Docket Item #10 A-C
100 South Pickett Street - The Delaney
Master Plan Amendment #2012-0002
Rezoning #2012-0001
Development Special Use Permit #2011-0007

| <u>Application</u> | <u>General Data</u> | |
|---|-------------------------------|--|
| <u>Project Name:</u> The Delaney | PC Hearing: | June 5, 2012 |
| <u>Location:</u> 100 South Pickett Street | Zone: | Existing: CG/Commercial General Proposed: CRMU-M with proffer |

Map 10
 Adopted Zoning

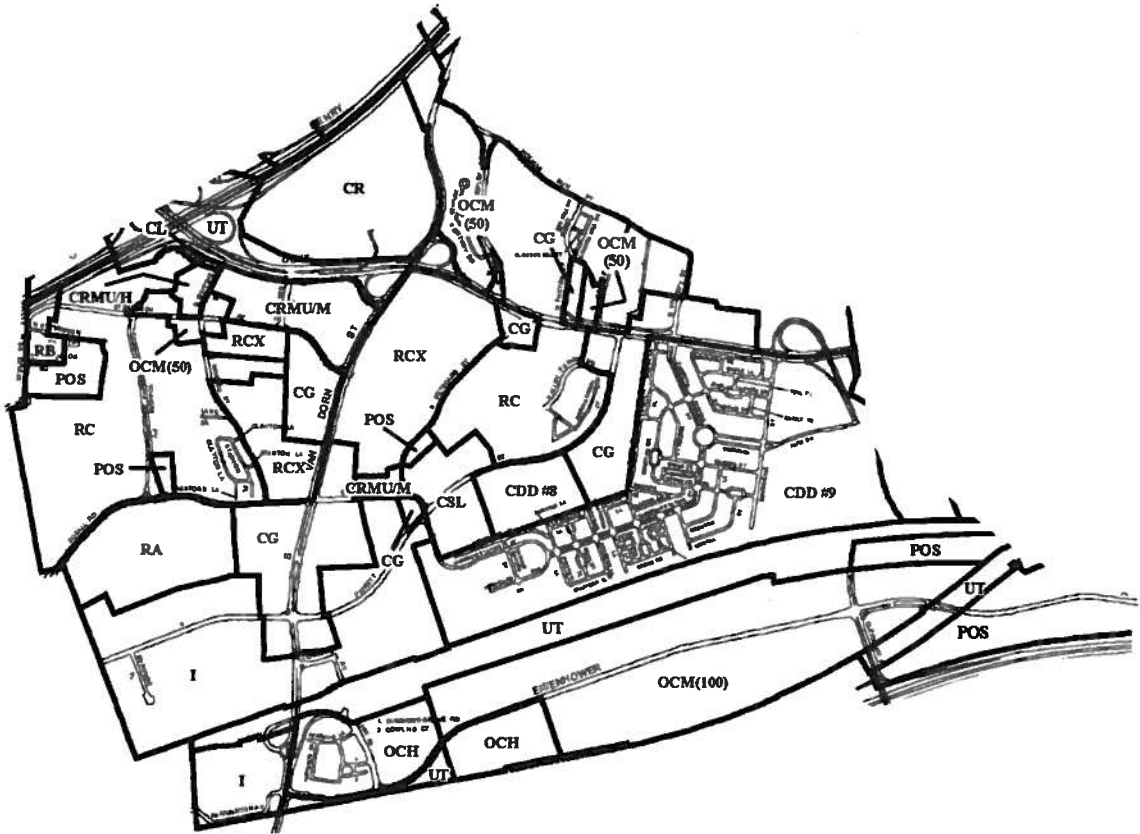
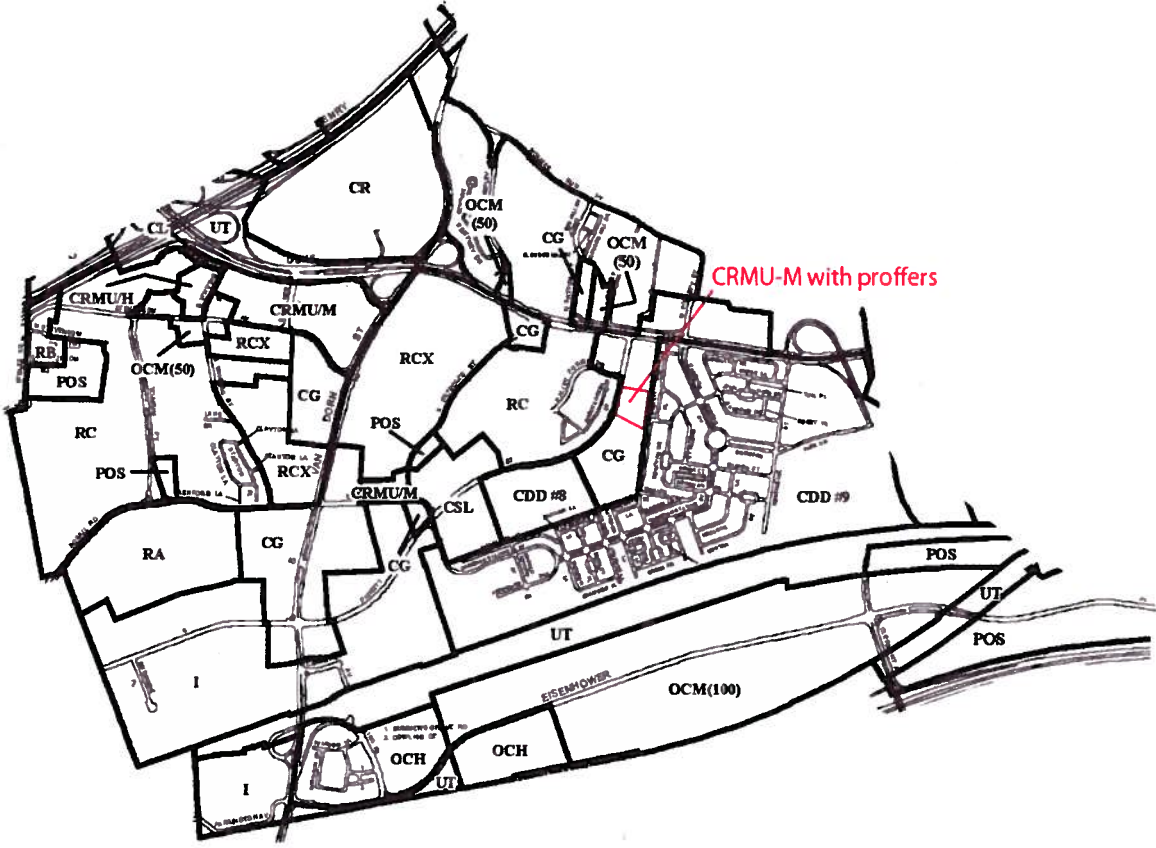
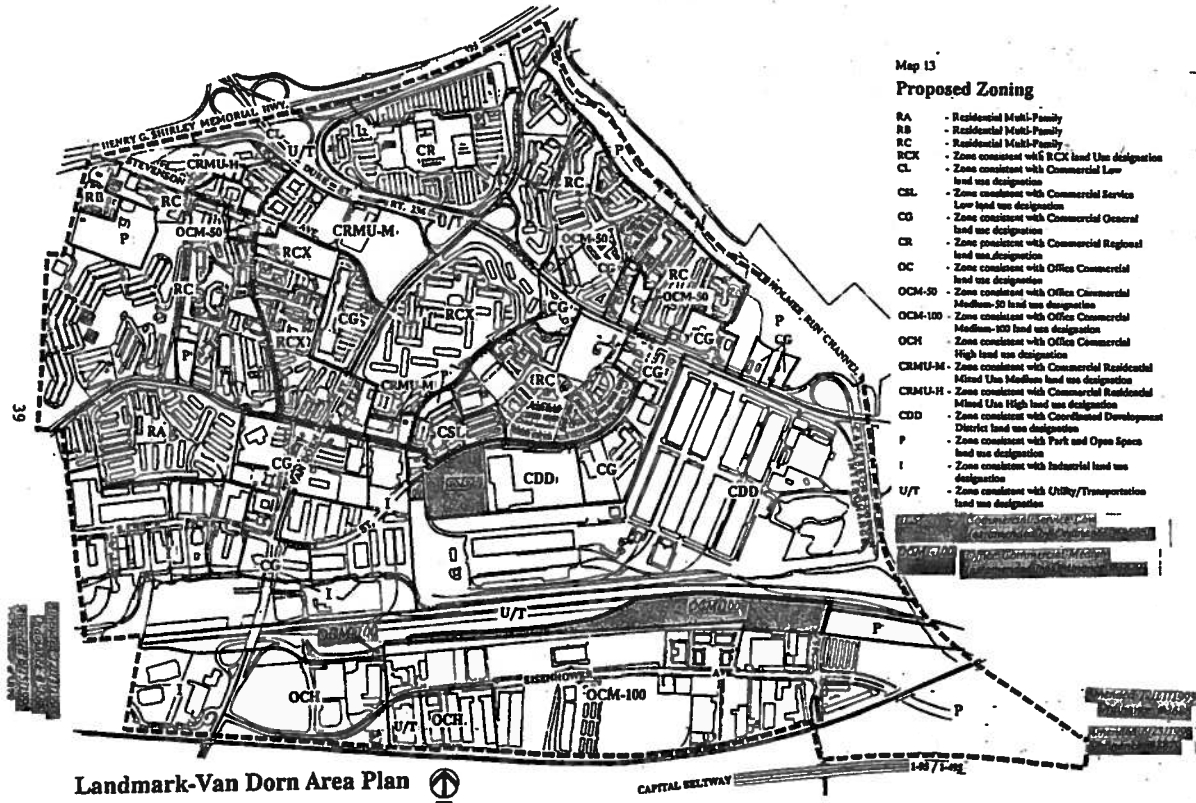
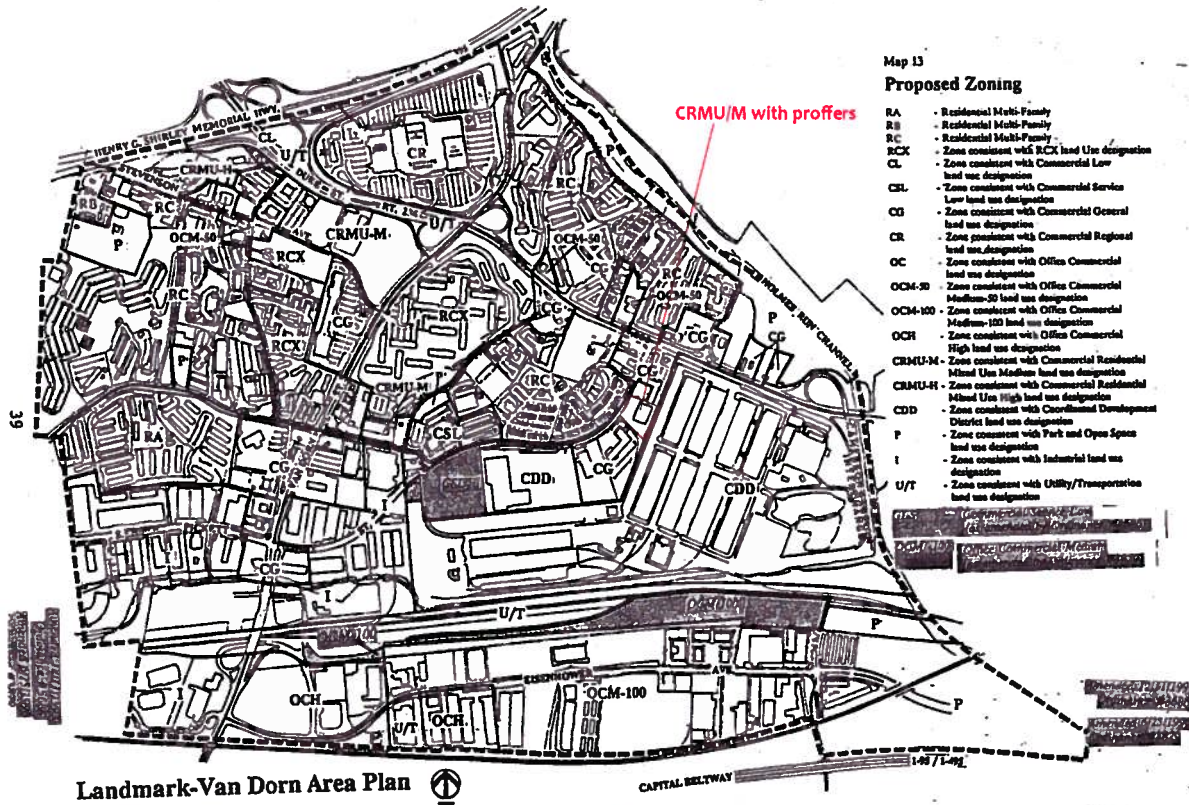
ATTACHMENT #4 – Master Plan Map Amendments
